RE: **Application for a Major Amendment to the Planned Development (PD)
 Application for Site Plan (Development and Design Review)**

STAFF REPORT

Requested Action: Approval of a Major Amendment to the Planned Development (PD) and Site Plan (Development and Design Review) Approval for the King’s Landing Mixed Use Development Project

**Re: Fort Pierce Redevelopment Agency
Kings Landing Development Review**

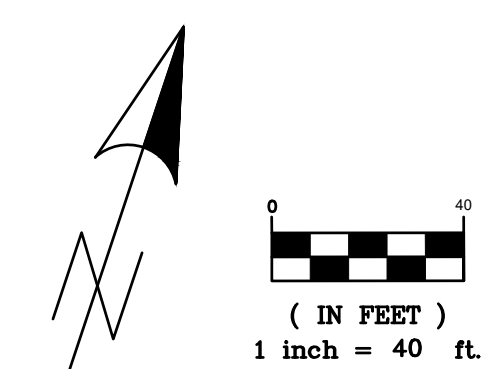
FPUA will require a utility easement for all propose FPUA facilities. [Please find attached a preliminary plan markup, showing the propose electric and Gas utility route.](#)

HD KING
KINGS LANDING
 SITE PLAN
 FORT PIERCE
 FLORIDA

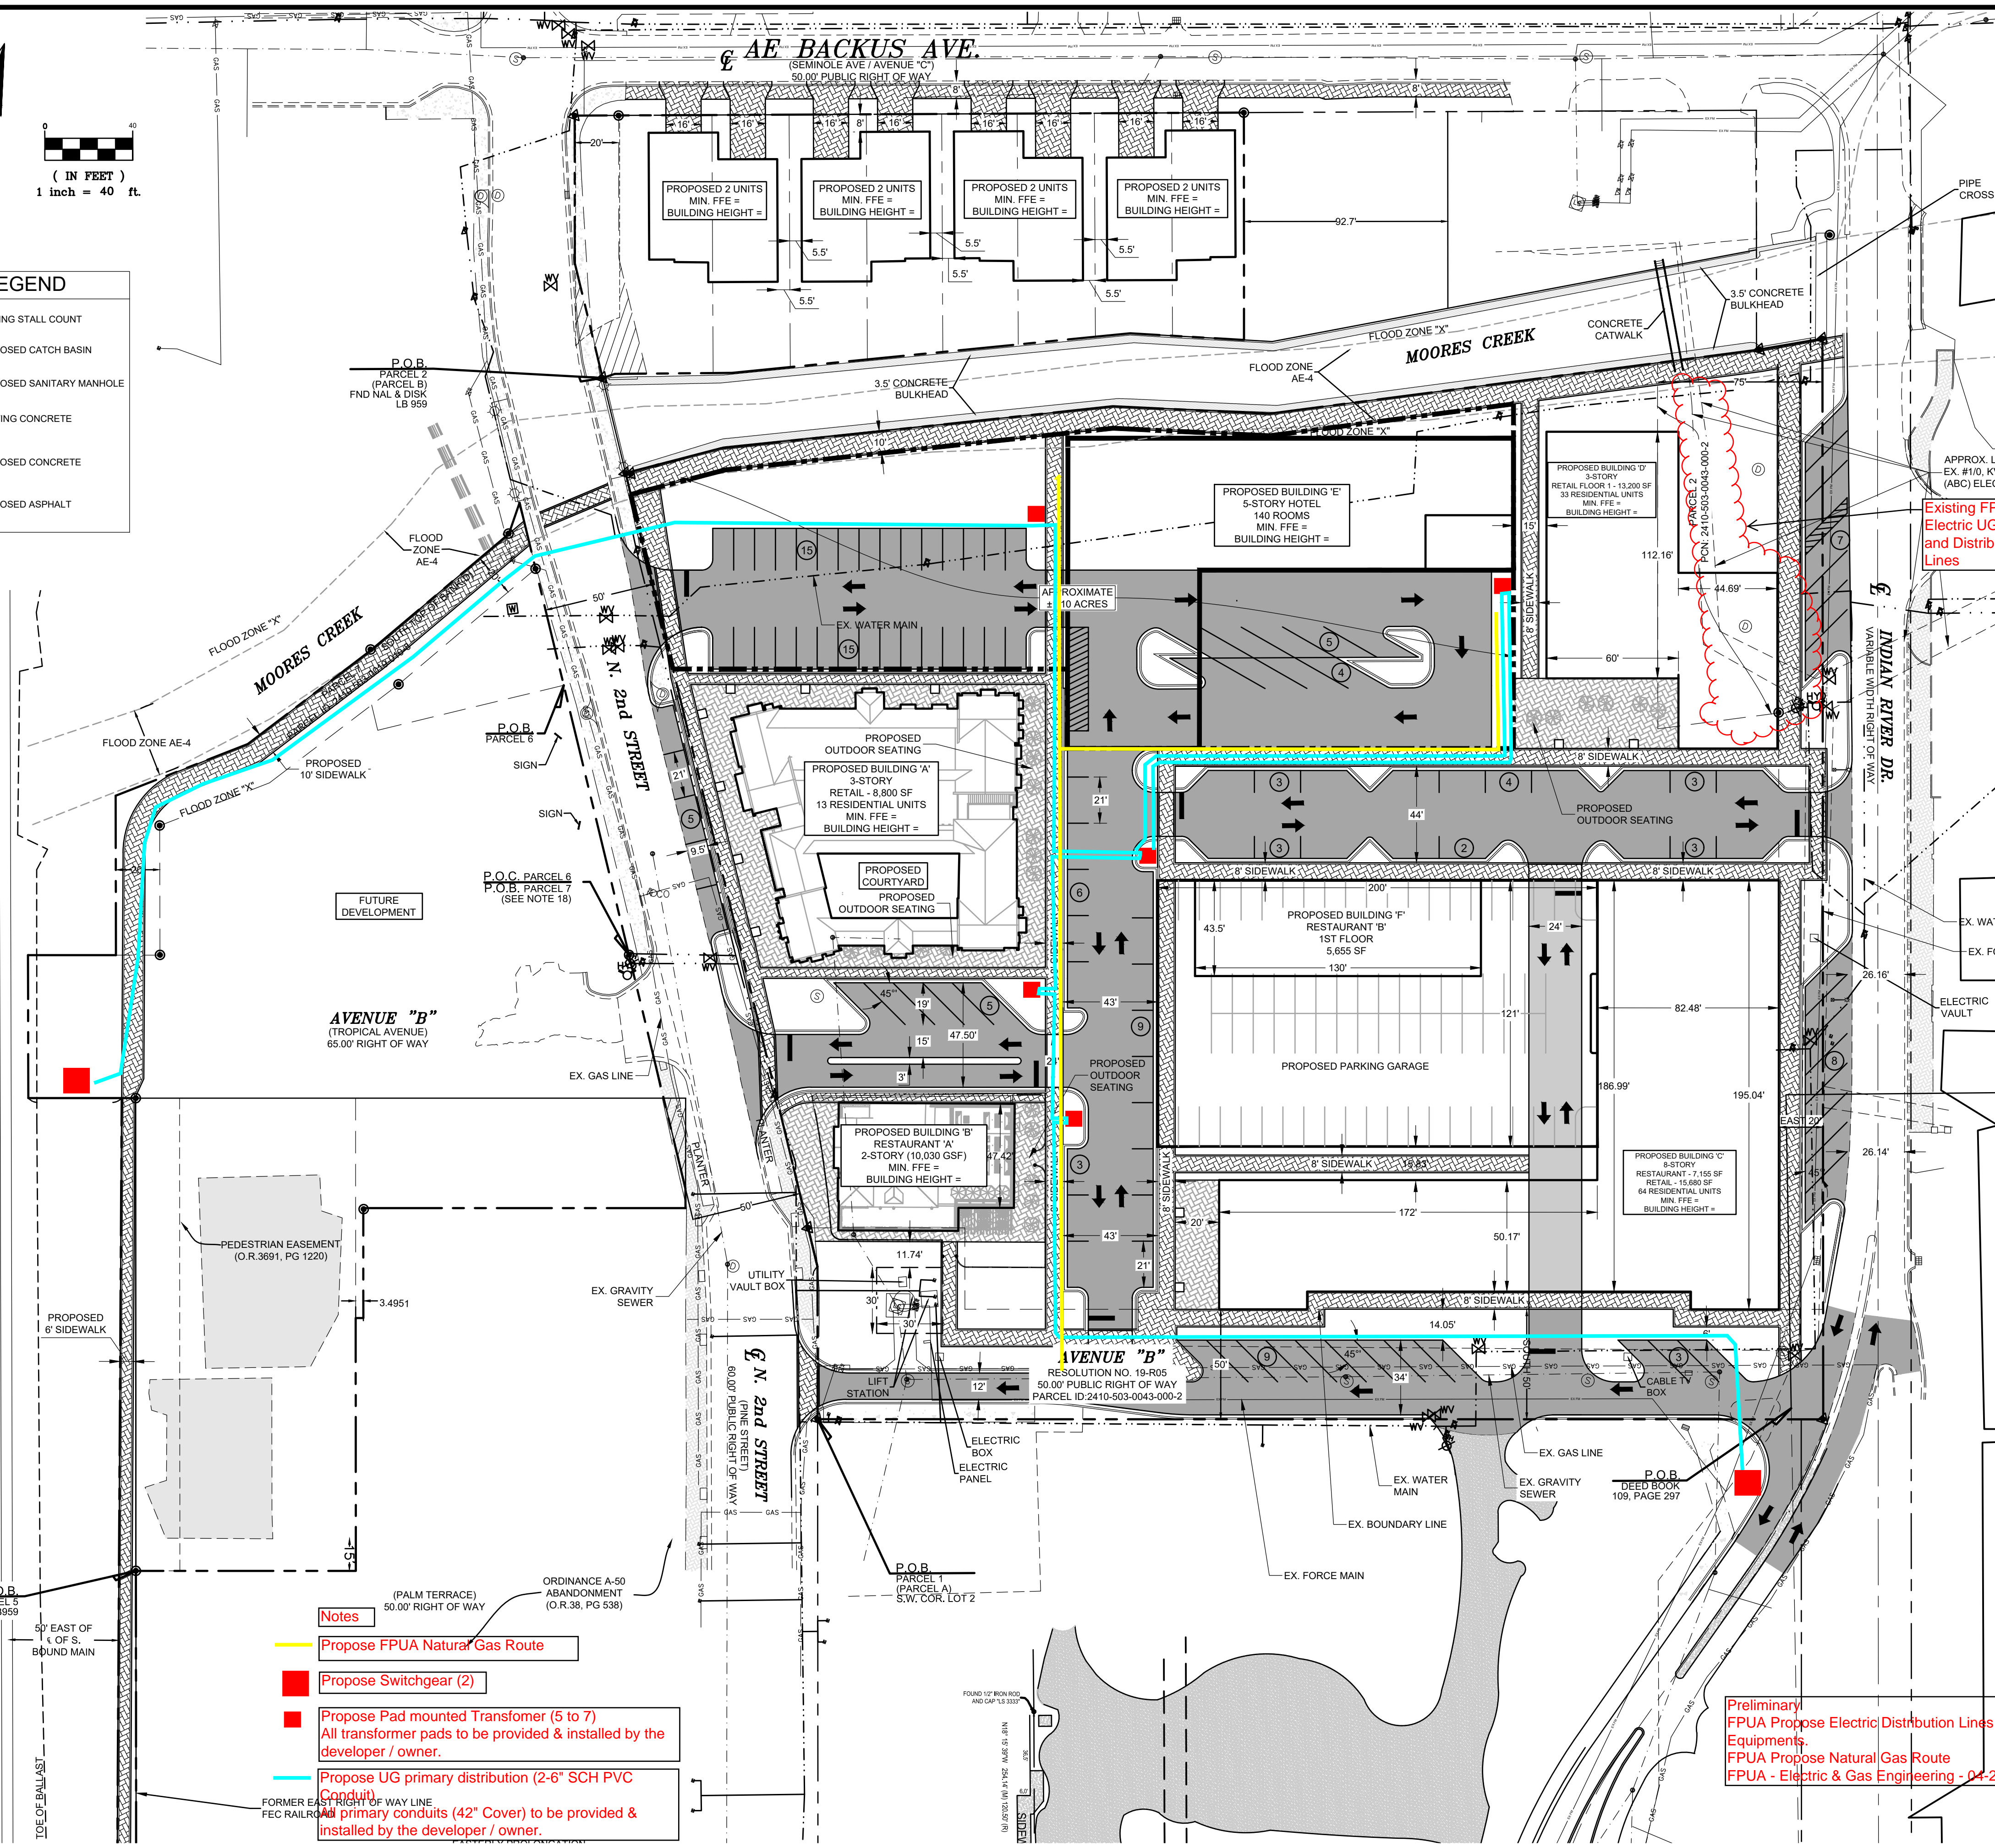
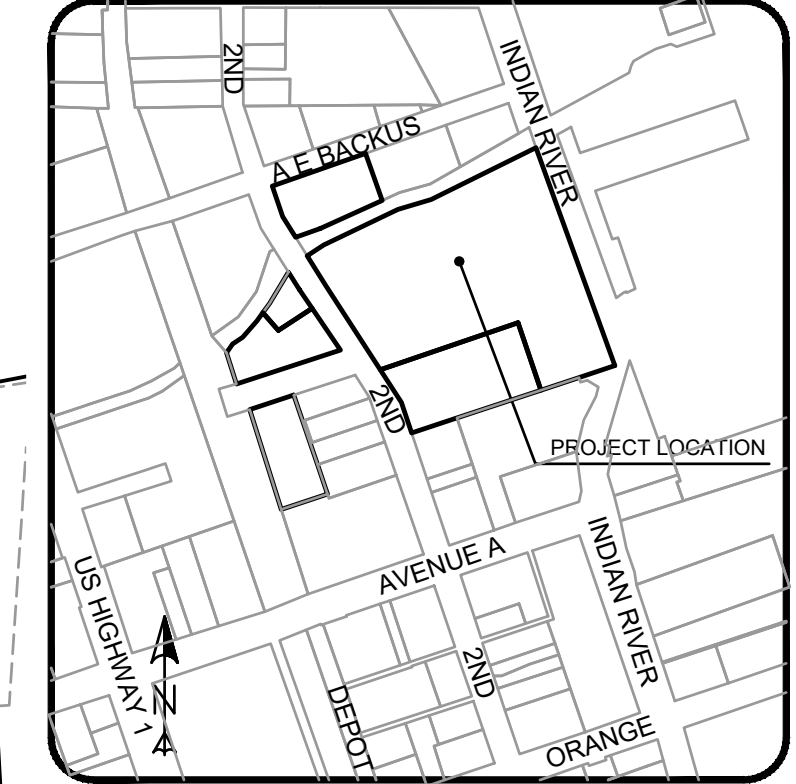
- Angled parking along Indian River Drive is not supported. The subject angled parking requires the vehicle to back into a travel lane, which is not allowed per City Code.

- There appears to be an abundance of parking as both surface and structured parking is proposed. The surface parking provided should provide landscaped tree islands every 10 spaces.

- Consider brick paver crosswalks at the interior Avenue B intersections to provide a pedestrian friendly environment and connect with the surrounding downtown area.

- What is the maximum height (show on site plan)?

- What are the setbacks (show on site plan)?

5. Avenue B is shown as having a one-way roadway width of 12' at the west end, please revise this width to reflect a 14' minimum on-way width.

8. There are three (3) driveways that access AE Backus that will only have an on-site depth of 8'. This is not sufficient depth to provide vehicle parking without encroaching into the right-of-way, please provide a minimum depth of 20' for vehicle parking.

9. Provide curbing within the parking areas as required per Section 123-37(11)(d).

RESPONSE: We are to the understanding that the City is meeting with the County to discuss the angled parking in an effort to include it as shown.

RESPONSE: Please see revised site plan which includes a landscape island every 10 spaces.

RESPONSE: *Concrete brick pavers crosswalks have been incorporated in the attached revise site plan.*

RESPONSE: Please see revised site plan. The maximum height is depicted on the plans.

RESPONSE: The setbacks are now depicted on the site plan.

RESPONSE: Please see revised site plan. This change is reflected.

RESPONSE: The site plan has been revised to reflect a 20' setback.

RESPONSE: Please see revised site plan which addresses this comment.
